Project: **La Jara Dental Clinic – Addition & Remodel** Project No.: 2614

Addendum No.: **02**

Date: **09/14/2026**

T-001

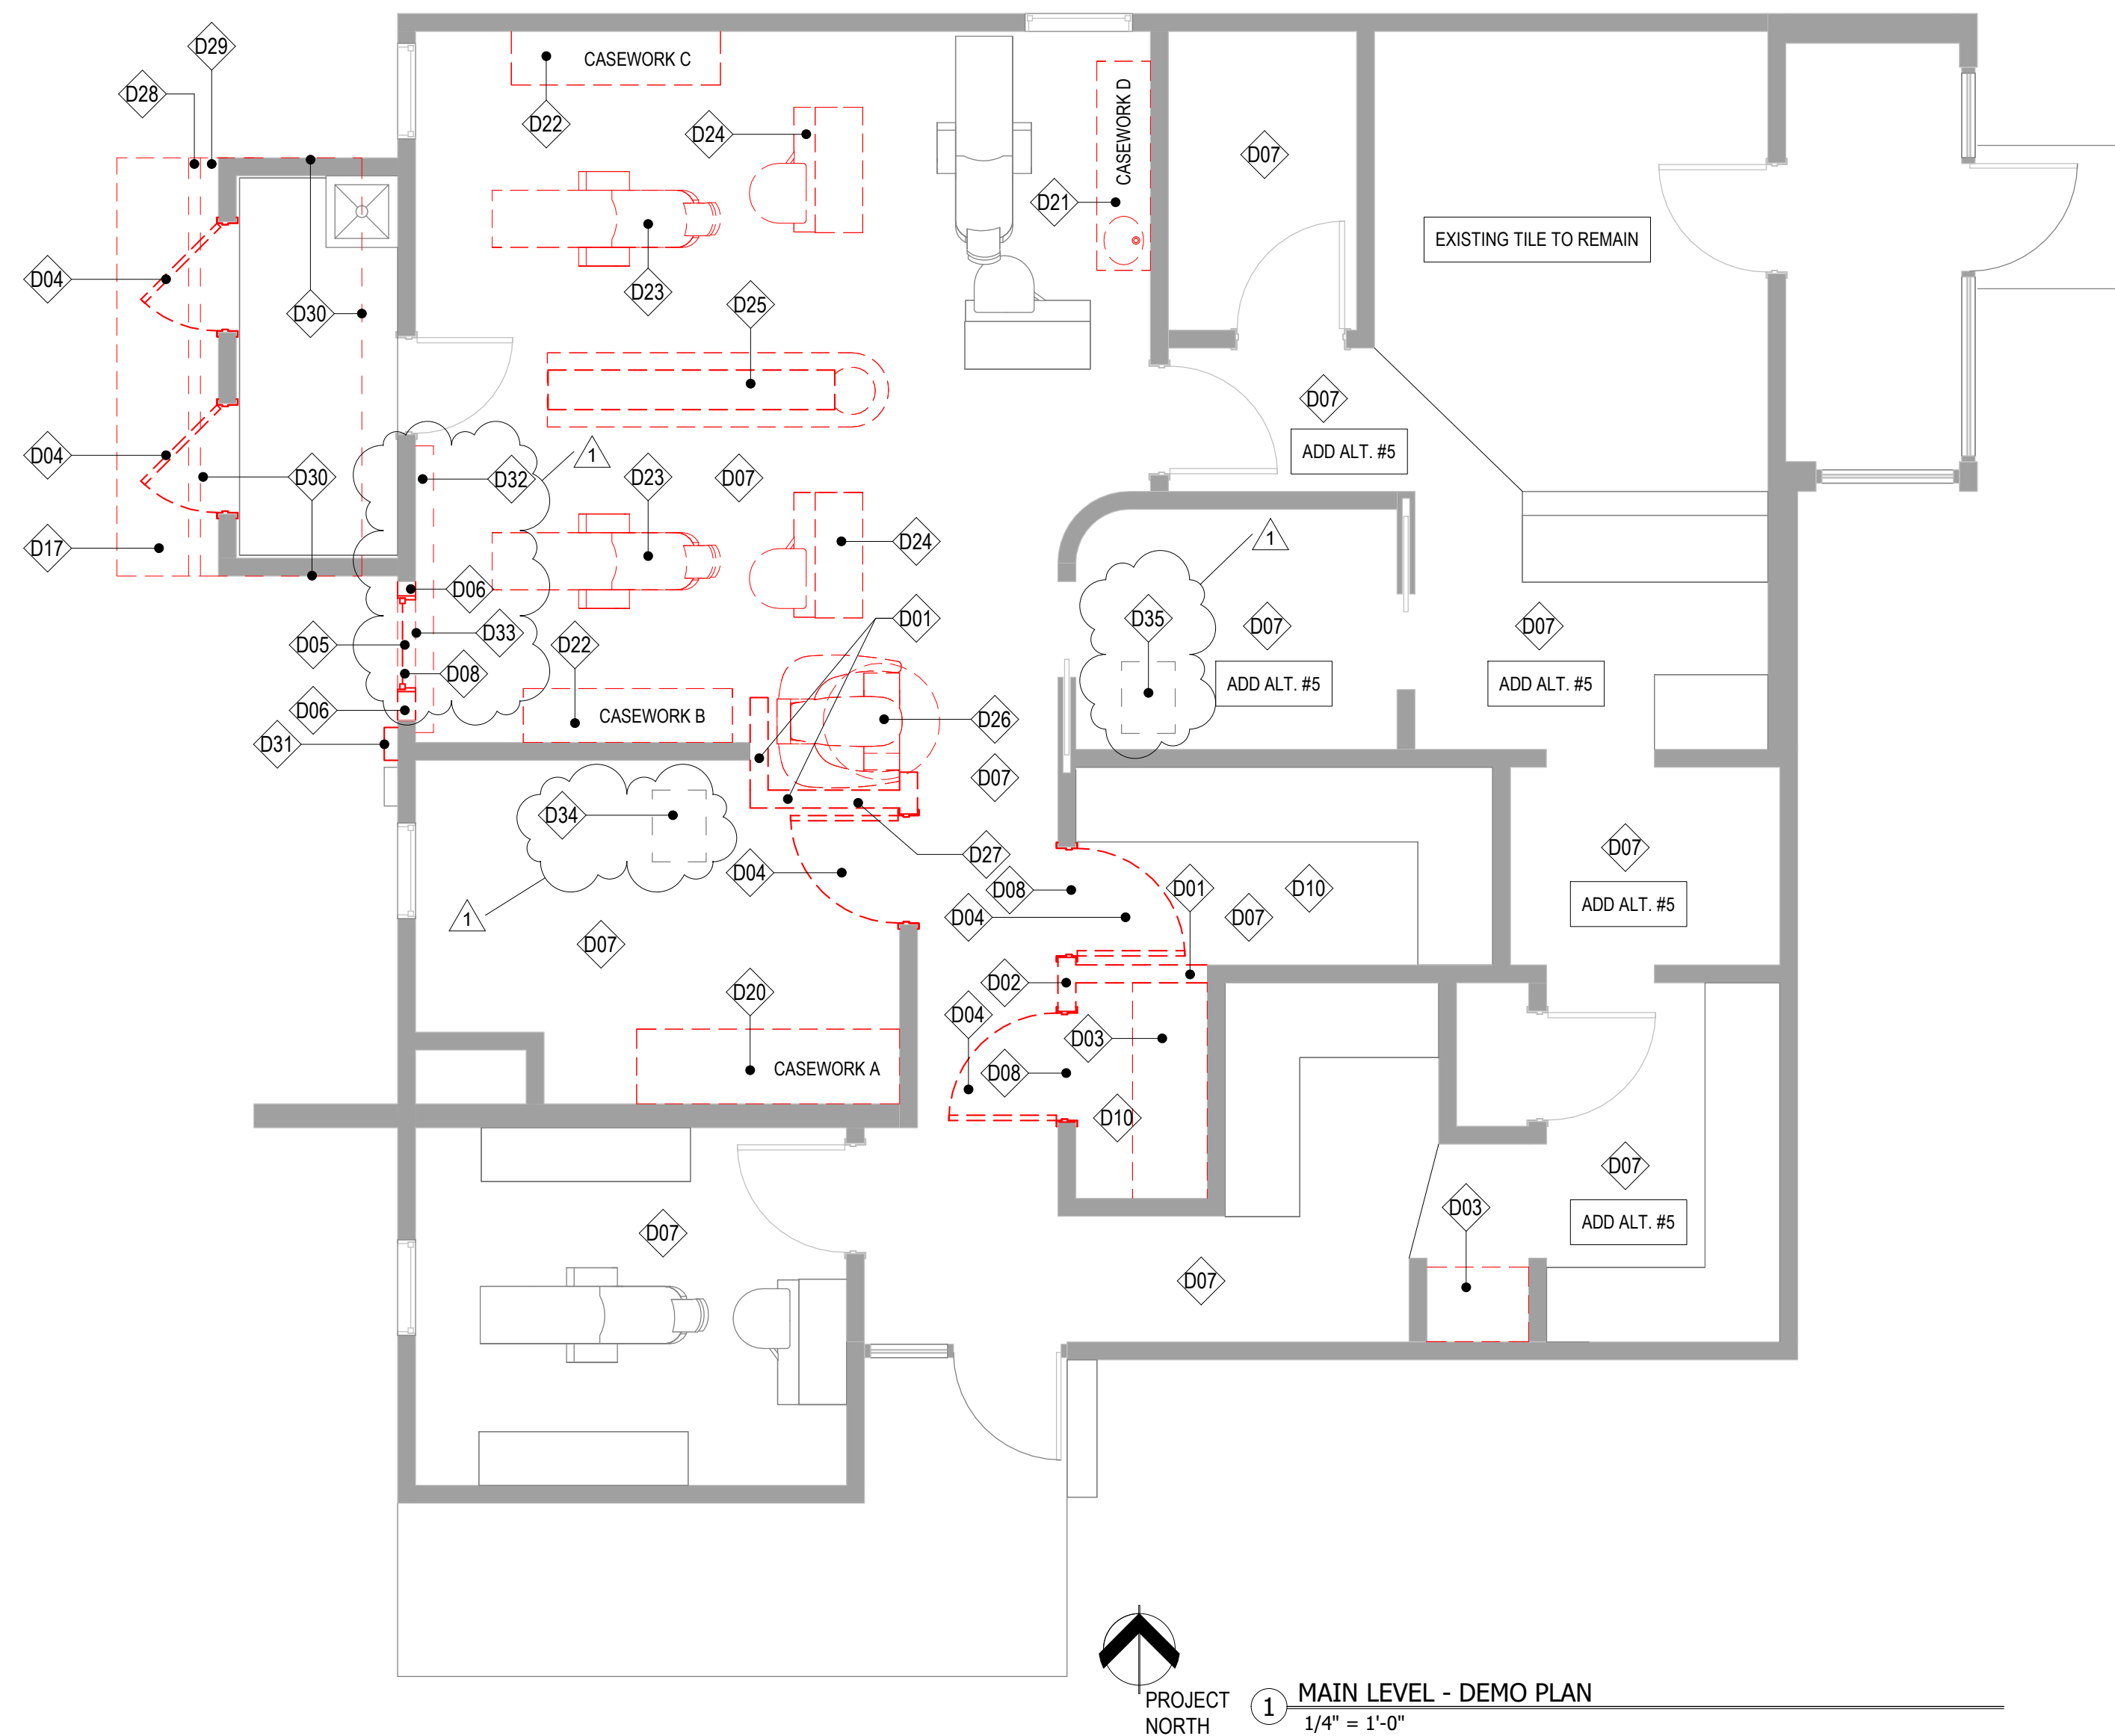
- a. T-001: Include \$5,000 allowance noted above. This requirement has been added to cover sheet.
- b. AD-101 & A-101 & M-111: Scope added to demo work on West wall. Contractor is responsible for removing baseboard heater and wire mold along this wall. If wire mold is in use, reroute wire and new wire mold up over new hallway opening.
- c. AD101 & A-101: Existing access to crawl space needs to move. Remove existing panel and infill per A-101. New access will be in office 106. Confirm exact location with owner on site. Flooring and sub flooring to be demoed for new access. Existing access panel to be reused.
- d. A-101: Carpet tile specification added.
- e. PD-111 & P-111: Remove and relocate existing cleanout as noted.
- f. ED-121 & E-121 & E-601: New electric service needed. Demo existing. Contractor to re-feed existing panel A from new service.

1. INCLUDE A \$5,000 ALLOWANCE TO BID FOR EXTERIOR IMPROVEMENTS. USE OF THIS ALLOWANCE WILL BE DIRECTED BY THE OWNER.

AD-101

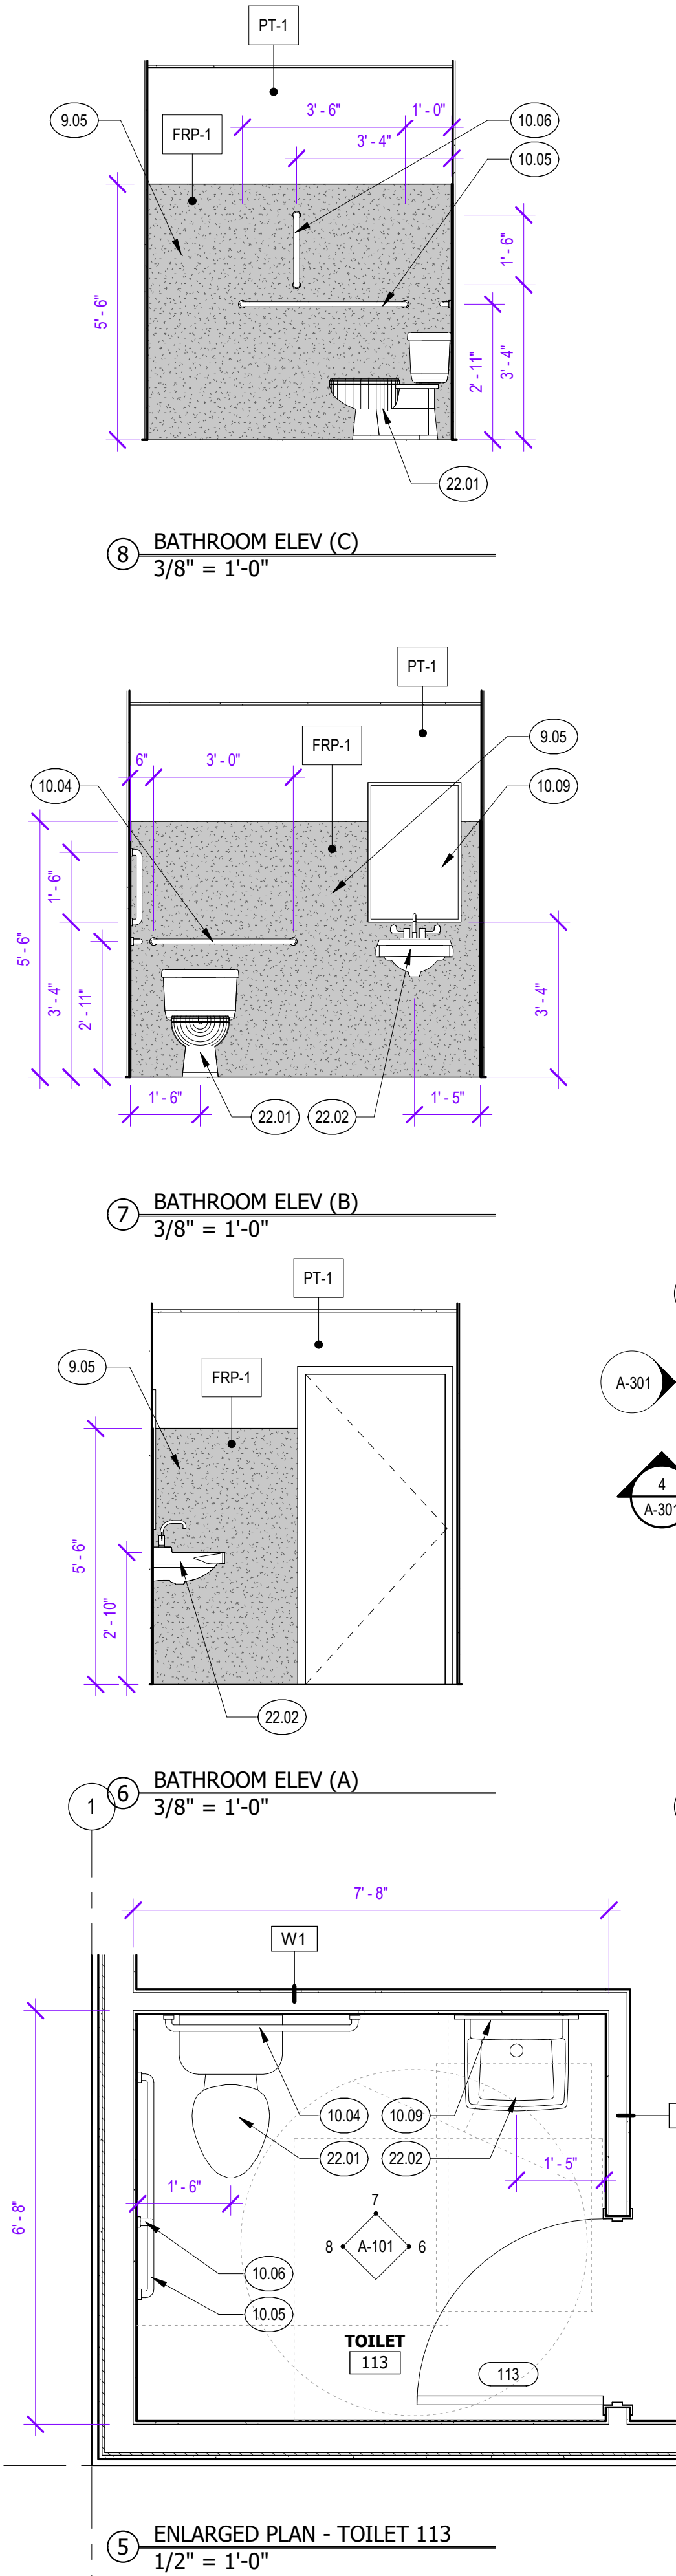
Sheet AD-101, Demolition Keynote D24, identifies two existing items to be removed and reused. Sheet A-101, Keynote 12.42, shows their proposed relocated positions. Both items appear to have the same footprint on the demolition plan, but one is shown with a reversed footprint on the proposed plan. Please clarify whether the existing item can be reused as shown or whether modification or replacement is required. **These 12'o'clock units are all identical – no modifications needed. (2) to remain in the open area and (1) moves into the Closed Op 115, positioned on East wall facing West.**

| D32 | REMOVE BASEBOARD HEATER |
| D33 | DEMO WIRE MOLD; IF IN USE, REROUTE WIRE AND NEW WIRE MOLD UP OVER HALLWAY OPENING |
